Cabinet Member for City Services

Objections to Proposed 20mph Limit & Speed Cushions – Leaf Lane

Appendix A – Plan of Proposed Road Safety Scheme

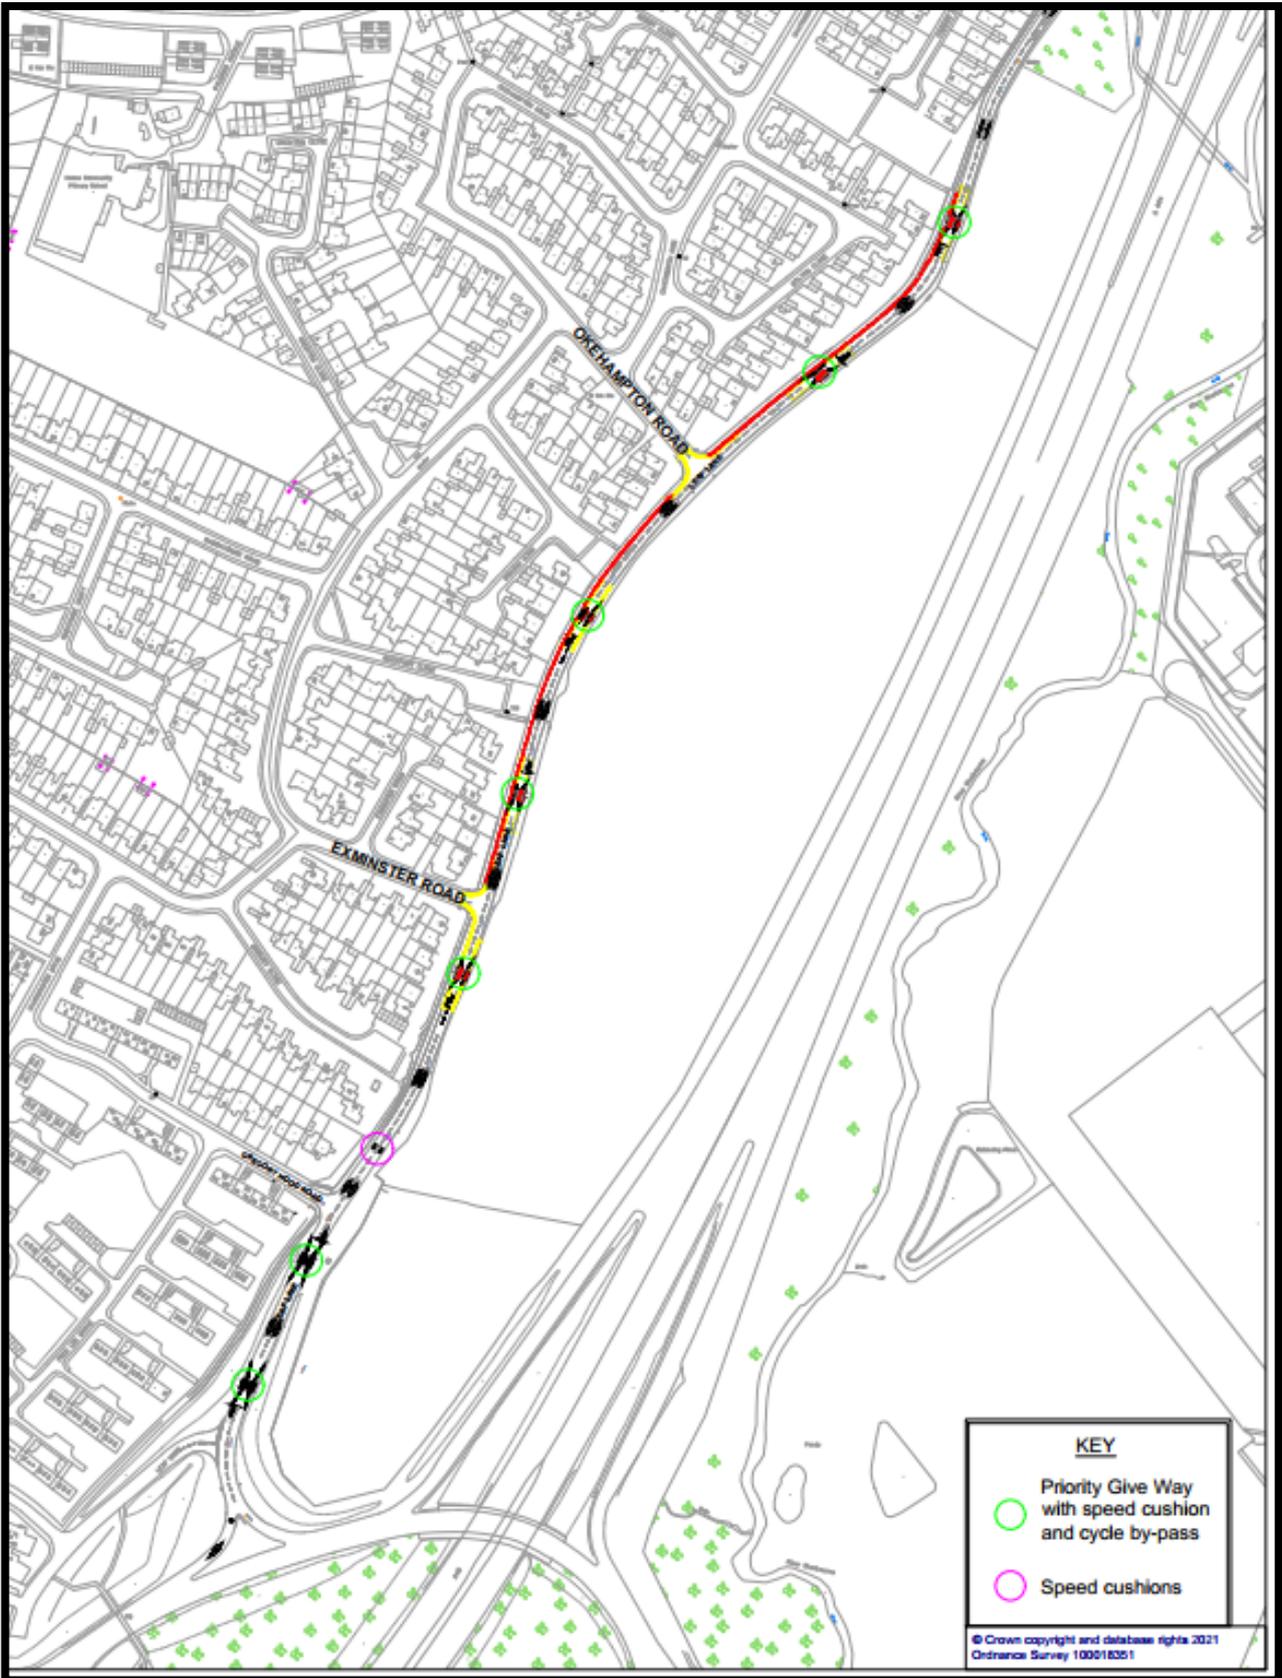
<p>Objection 1</p>	<p>I object to the 20mph speed limit proposed for Leaf Lane and have experienced no problems with the present 30mph. I have also not witnessed any speeding. I also object to the proposal to introduce priority give ways, which were not mentioned in the draft proposal. For such a short distance it is likely to create a stop start situation leading to higher health problems due to the emissions from the vehicles.</p> <p>This is a case of “if it’s not broken then leave it alone”. You appear to want to change things for the sake of changing them.</p>
<p>Response to Objection</p>	<p>Local residents have raised concerns about the speed of vehicles since the opening of Whitley Junction. The 20mph speed limit, speed cushions and the priority give-way measures are designed to optimise road safety for all road users of Leaf Lane. Leaf Lane is a long straight and the measures are designed to ensure drivers focus on the immediate highway environment and not in the far distance in front of them – a phenomenon known as tunnel vision.</p>

<p>Objection 2</p>	<p>We agree with the proposed 20mph speed limit for Leaf Lane, but strongly oppose the use of Speed Cushions, due to the damage they cause to vehicles, and Government research has found that both Speed Cushions, and traffic calming Chicanes increase emissions, which is detrimental to the environment. The Speed Cushions will deter motorists from using Leaf Lane, and will force motorists, and those speeding, into more populated roads, where youngsters may be playing, or walking to school, pedestrians crossing roads to shops, or bus stops etc. Junctions such as Leamington Road/Baginton Road are busy enough without extra traffic pushed in that direction. Speeding motorists is not unique to Leaf Lane. It’s going on regularly in Dawlish Drive, Babbacombe Road, Exminster Road, Knoll Drive, Watercall Avenue, The Chesils, Dillotford Avenue, Fenside Avenue, and maybe across the City Your proposal will only push Leaf Lane’s problem elsewhere and make all the surrounding roads a more dangerous place to be.</p> <p>It would also be beneficial, and safer to both cyclists, and pedestrian traffic, to encourage cyclists to use the more populated roads, and off Leaf Lane.</p> <p>The funds to pay for such a scheme would best be spent on enforcement, preventing speeding and dangerous driving, and preventing you spending more money on traffic calming on the next street that somebody complains about.</p>

<p>The speed limit of 20mph is completely unacceptable for a main road into a large neighbourhood, particularly when that road does not even have any driveways exiting into it. Installing speed cushions on a main access road makes no sense. It is well known by anyone that has ever driven a car over a speed cushion that if the limit on that road is 20mph, going over that cushion at 20mph will wreck your car. If you are so concerned about speeding, install a speed camera. The layout of the one way system makes no sense, as it is installed in an area where two way traffic does not create any sort of risk to anyone or anything. There aren't even houses on that stretch of road. What's more, this one way system is placed in an area of poor visibility from both sides. Drivers coming into Leaf Lane off of the Stivichall Interchange cannot see any traffic coming through the one way system, and drivers coming south on Leaf Lane cannot see the one way system on account of the hill top right in front of Gregory Hood Road. Then there is the matter of this one way system complicating matters even more when coming into Leaf Lane from Festival Pub, an exit with very poor visibility to the right, and now a one way system to the left. Who is this one way system supposed to help? As far as i can tell, it just makes life difficult for drivers, and when drivers are placed in difficult situations, they make mistakes.</p>

<p>Objection 4</p>	<p>The grounds for our objection start with the lack of evidence in favour of the change. Can you please supply 3 years history of road traffic collisions in that specific area? Including casualties. Evidence of recorded excess speeding over a prolonged period of time. Preferably including evidence from before the main island was being modified for the Whitley expansion. Evidence of through traffic accessing London road using Leaf Lane as a cut through. Again preferably including evidence from before for the island modification. The number of vehicles traveling through this area. Furthermore, the area in question has no residential frontage. There is a cycle path that avoids this section. There are no foot paths next to the majority of this section of road. As such and in the absence of thorough supporting information requested above we fail to see the justification for any change in the road furniture or speed. We believe that implementing this measure will:</p> <ul style="list-style-type: none"> Increase emissions in this area which will increase air pollution for any ambulating or cycling member of public in a larger local area. Increase the risk of accidents when people try to negotiate this area. Increase in road rage of people who have not been allowed through appropriately. Cause a hindrance to the emergency services accessing the main road network from this residential area as well as accessing this residential area from the main roads.

<p>Response to Objection</p>	<p>A 20mph speed limit through signage alone is not effective on long straight roads. Subsequently, physical measures such as speed cushions are used to ensure the speed limit is adhered to. Vehicles travelling at 20mph instead of driving at high speed then slowing down should not be detrimental to vehicle emissions. In terms of traffic migration, we will undertake post installation surveys to evaluate the effects of the scheme on surrounding roads.</p>
<p>Objection 3</p>	<p>You claim that there are concerns about vehicles speeding. If people don't respect the speed limit, what makes you think changing the speed limit will work? Secondly, there is no reason to lower the speed limit as 30mph is a perfectly adequate speed for a stretch of road with no pedestrian access, no driveway exits, no hidden exits, no parking allowed, no houses. You claim that there are concerns about drivers using Leaf Lane as a "cut-through". The purpose of Leaf Lane is to provide access to the neighbourhood just west of it. It is meant to be a high traffic road. If you limit traffic on this road, everyone will make their way through the other streets, packed with park cars, and children, and homes, and driveways. What is the reasoning of cutting traffic through a street purposefully designed for relatively high volume traffic, and shifting all that traffic through streets that cannot accept that traffic safely?</p>

<p>Response to Objection</p>	<p>Residents have raised concerns, and officers have conducted extensive observations that some vehicles may be travelling at excessive speeds on Leaf Lane. Reducing the speed limit to 20mph coupled with physical traffic calming measures will create a safer road environment for all road users. Residents raise concerns that since the opening of the Whitley Junction; vehicles are using Leaf Lane from Stivichall Interchange to A444 during peak times. Observations have confirmed this. Speed cushions are self-enforcing and are proven techniques used to ensure speed compliance. Vehicles traveling over speed cushions at appropriate speeds will not result in any damage to their vehicles. This location is unsuitable for speed cameras. The one-way system is aimed to reduce vehicles using Leaf lane as a cut-through. However following the initial informal consultation, this technique has been removed from the scheme as 66% of residents objected to it.</p>

<p>Response to Objection</p>	<p>This scheme is not a Local Safety Scheme. It is a developer funded scheme aimed at mitigating the impact of the new grade separated Whitley Junction. The scheme considers the impact to residents including traffic volumes, speeds and feedback from residents. We have received considerable complaints from residents about traffic volumes and speeds. Residents have confirmed that traffic volumes have increased considerable since Whitley Junction has opened. Officers have observed the increases in traffic volumes at peak times and excessive speeding. There has been 3 personal injury collisions on Leaf Lane over the last 3 year period, including 1 serious. Our speed surveys show that vehicular speeds are excessively over the 30mph speed limit, and the northbound 85th percentile speeds are recorded as 39mph and the northbound 85th percentile speeds are recorded as 41mph. This</p>

<p>is significantly over the 30mph speed limit. Vehicles travelling at 20mph instead of driving at high speed then slowing down should not be detrimental to vehicle emissions. In terms of traffic migration, we will undertake post installation surveys to evaluate the effects of the scheme on surrounding roads. The measures have been carefully designed to not have any detrimental effects on emergency vehicles.</p>
<p>Objection 5</p>	<p>I'm writing regarding the proposed updated road safety scheme on Leaf Lane. Me and my wife are homeowners at Postbridge Road, both commuting to work using Leaf Lane. I greatly appreciate your endeavour to improve the safety of that road. As an avid cyclist, I cycle along Leaf Lane to work at the University almost every day. I'd like to object to one of the proposed measures however - precisely the speed cushions. As an objection must state the grounds - speed bumps are proven by UK scientists to negatively affect the surrounding environment, they increase the noise and pollutions generated by 2 to 3 times. The reason is that cars will stop and then accelerate aggressively after the bump, which is awful for local residents and any unlucky cyclists to be around. Another bad side-effect is that cyclists, capable of taking over cars on speed bumps, end up being passed multiple times by the same car. This multiplies the risk probability. Considering these facts, I find it difficult to agree with the concept of speed bumps on this road, and therefore object to this solution. Let me note however I really appreciate your efforts and hope you'll find a better, more suitable solution.</p>
